RE: Site Plan Approval for 140 Court Street; Portsmouth Housing Authority

We hereby submit, on behalf of the Portsmouth Housing Authority, this **Response to Comments** for consideration at your August 7 TAC Committee Meeting. The response is based on the July 31 email comments as well as comments from the July 31 TAC meeting. Comments shown below with responses in **bold text**:

WORKFORCE HOUSING DEVELOPMENT

160 COURT STREET

OFF-SITE
IMPROVEMENTS PLAN

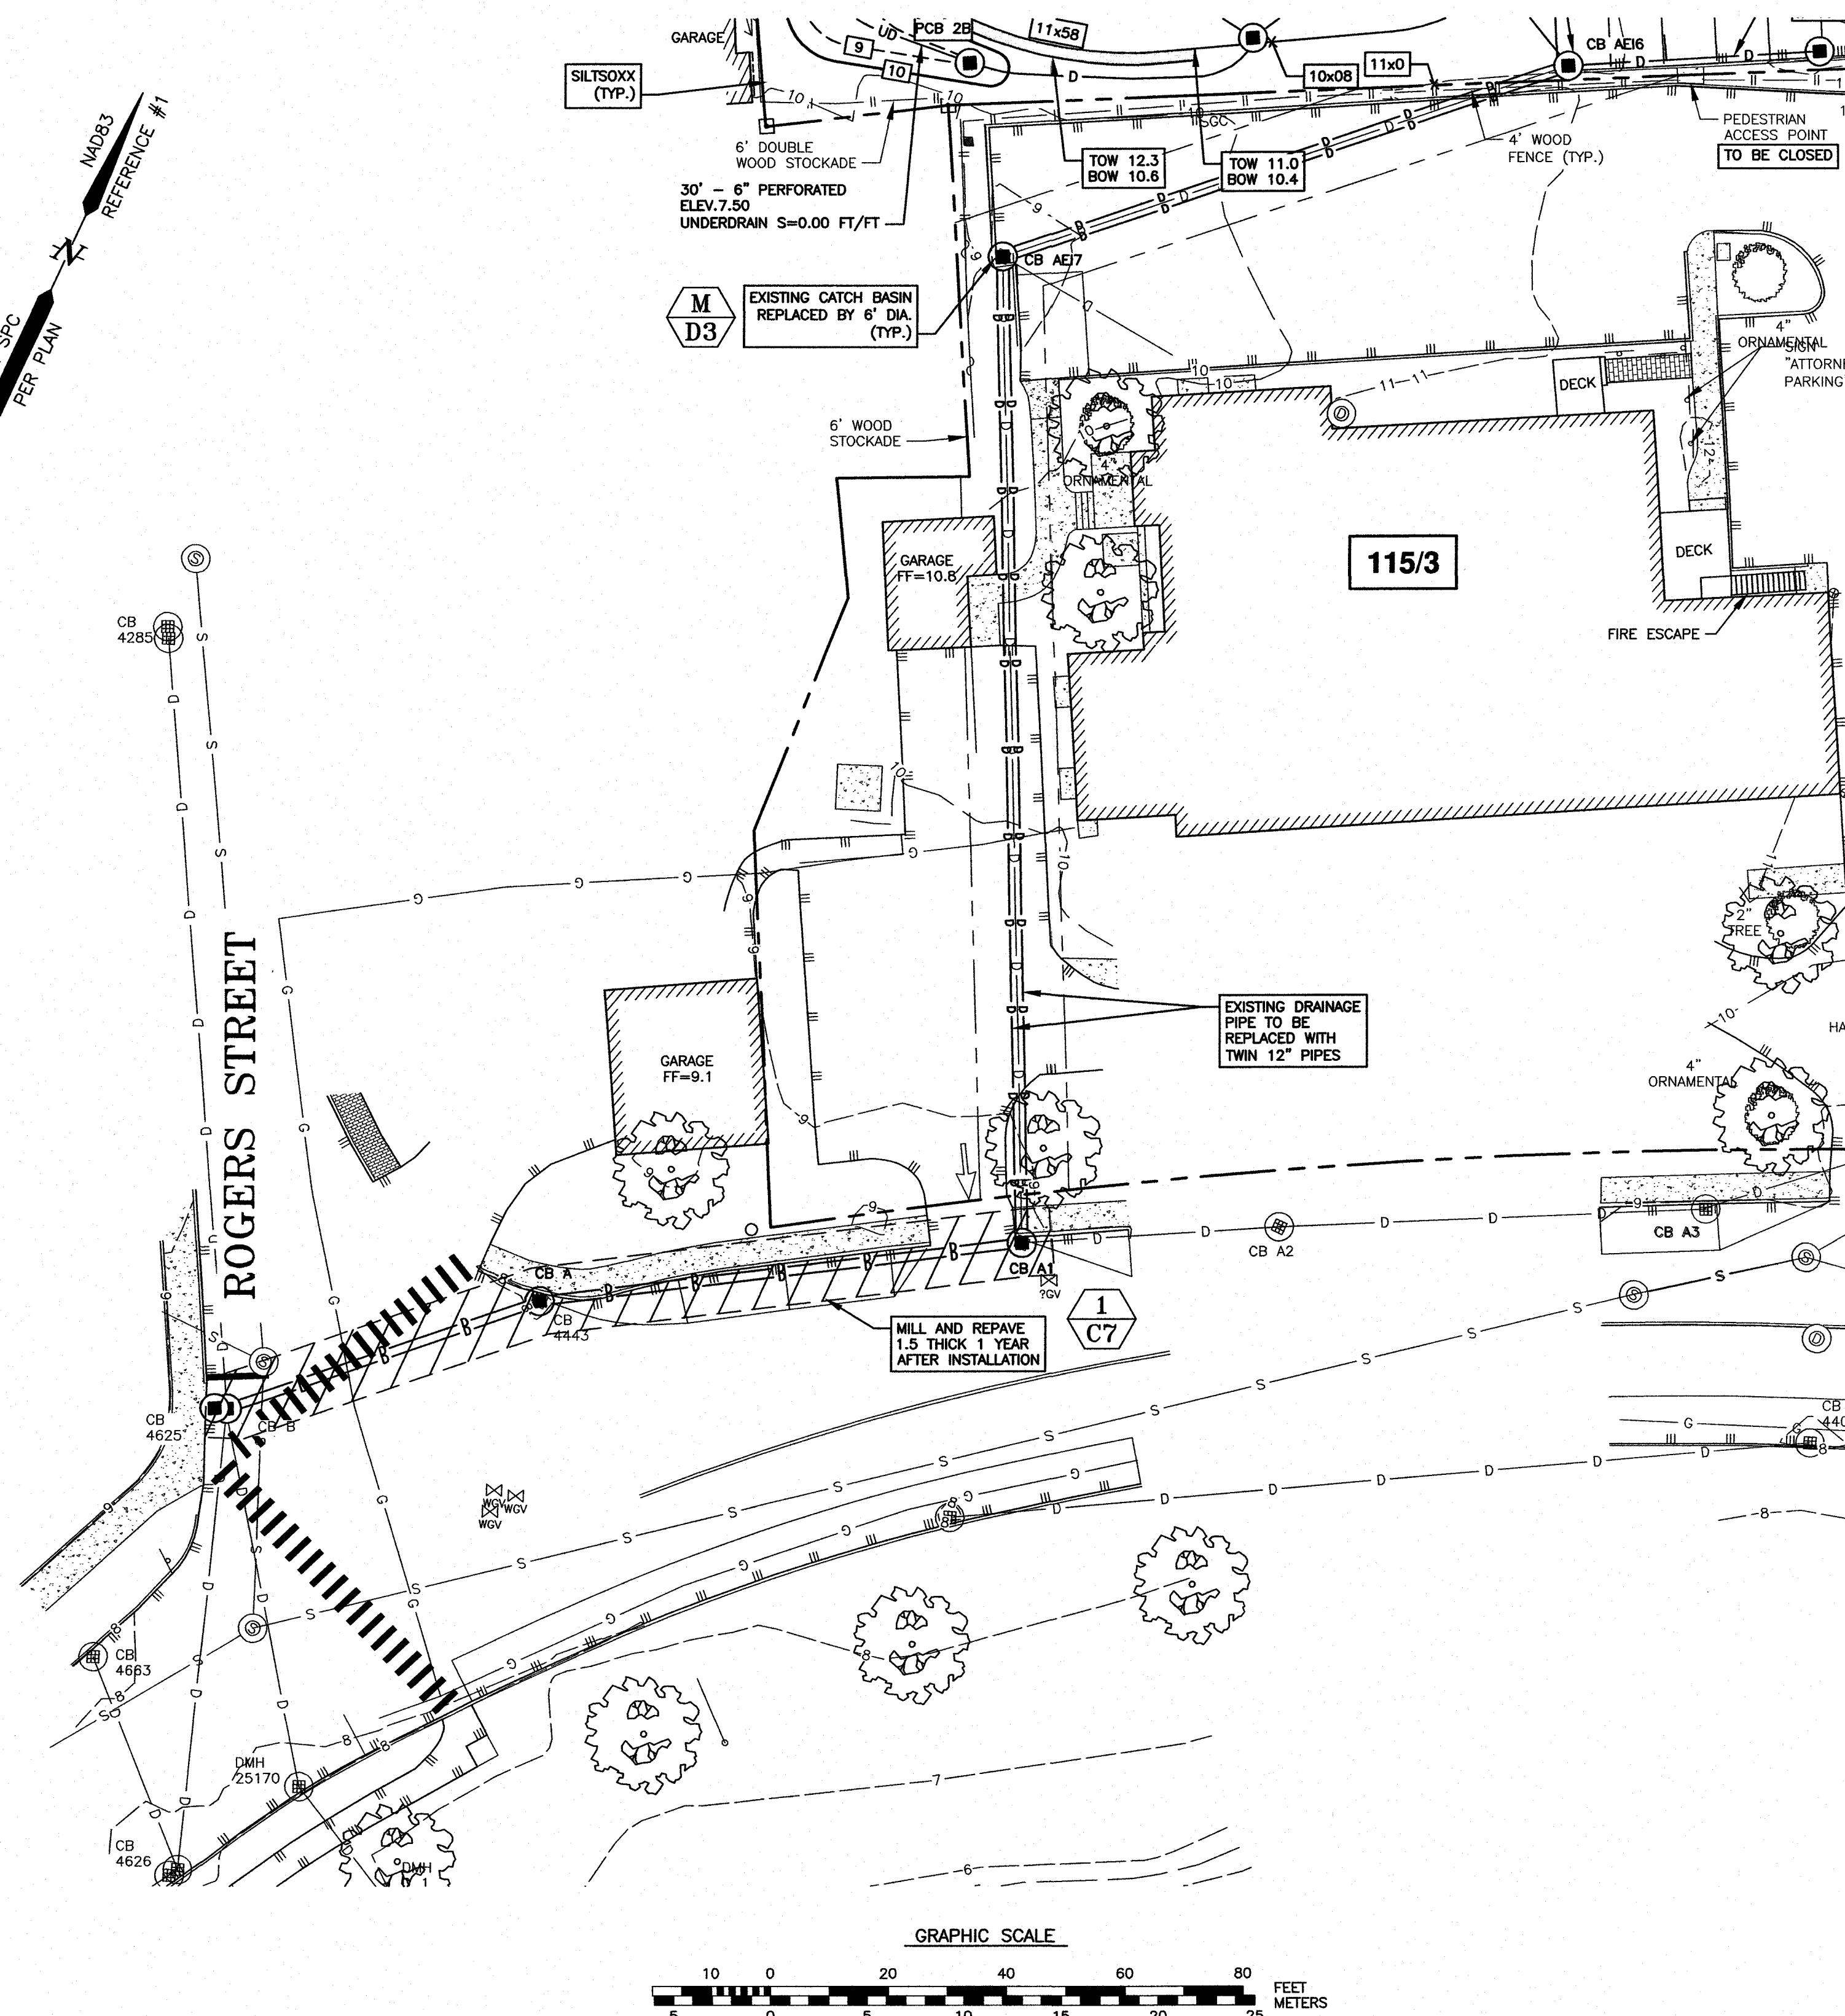
16. Roadway restoration is required for installation of 24" pipe. Provide permanent trench patch detail. Width of patch to be determined by City. **The Off-site Improvements Plan C7 has been expanded to show street detail and this restoration area / note will be added.**

20. Sheet C7: Shed indicated to be relocated. Ownership of shed? Where is shed to be relocated? **The shed will remain as the sidewalk has been eliminated from the development proposal.**

21. Sheet C7: Why are trees indicated to be removed? Sidewalk location/width or other adjustments might need to be made. Are trees to be replaced? **Due to the conflicts listed above the sidewalk has been eliminated from the development proposal.**
